Subject: East Vail Parcel Geologic Hazard Analysis – Review of Updated Site Plan**Date:** May 24, 2019**To:** Michael O'Connor, Triumph Development**From:** Julia Frazier, Skyline Geoscience

Skyline Geoscience (Skyline) has reviewed the Grading and Drainage Plan (Plan) by Alpine Engineering, Inc. (Alpine) dated May 17, 2019. This Plan is an update from the Preliminary Grading Plan by Alpine dated January 25, 2019. The Plan shows a 12-foot high earthen rockfall barrier with a 1V:1H slope on either side of the crest, spanning a length of about 620 feet and located upslope from the proposed structures (Figure 1). The location of the berm on the east end of its length has been relocated upslope about 85 to 95 feet from the location previously analyzed for the Geologic Hazard Analysis (original report; February 12, 2019). The Plan also shows changes in the number and location of residential structures, and site grading and drainage.

FIGURE 1
Proposed Development

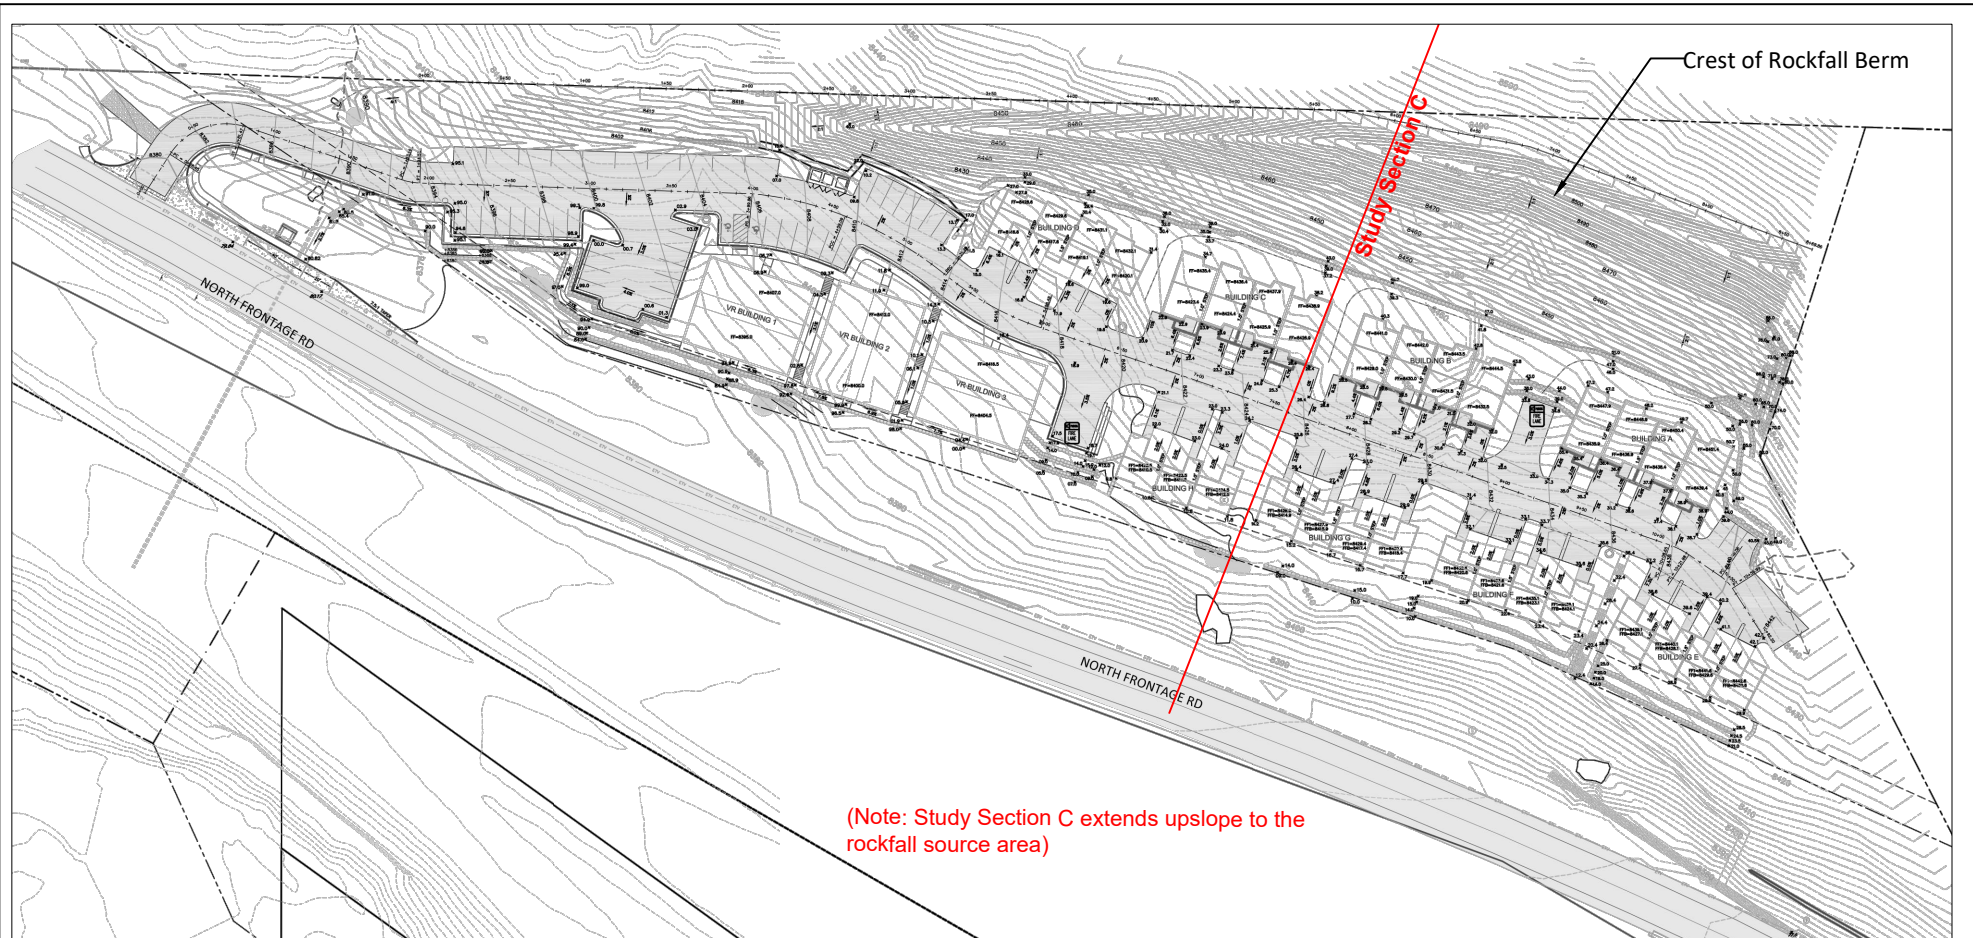
The Colorado Rockfall Simulation Program (CRSP) analysis for Study Section C has been updated to reflect the relocation of the barrier. Moving the barrier upslope is moving it closer to the rockfall source. The analysis point (AP) is associated with the location of the crest of the proposed barrier. Slope profile parameters were not changed from those stated in the original report. Study Section C was analyzed: 1) in the natural, current condition without a barrier, and 2) with the barrier placed at the location shown on the Plan. The results for the natural condition analysis are reported in Table 1. The maximum estimated values and the 95% and 98% statistical cumulative probability values are reported for velocity, impact energy, and bounce height.

A 10-foot high barrier placed at the location shown on the Plan for Study Section C stopped all 10-foot spherical rocks in the CRSP model. Due to overtopping conditions that may occur and due to the size of boulders observed on the ground surface within the property limits, the recommended height of the rockfall barrier is 12 feet (as shown on Figure 1). Based on the results of the CRSP analysis for a spherical, 10-foot diameter limestone rock, the barrier should be designed and constructed to withstand the maximum estimated impact energy of 3,000 kJ (about 2,200,000 ft-lbs), velocity of 36.8 ft/sec, and bounce height of 3.5 ft. These values have increased from those reported in the original report for Study Section C at the location of the proposed berm. Refer to the original report for other recommendations related to rockfall berm system and catchment area construction, maintenance and access. Skyline and Cesare, Inc. (Cesare) should be contacted for additional consultation and review if other rockfall barrier systems are considered or if changes are made to the Plan after the date of this memorandum.
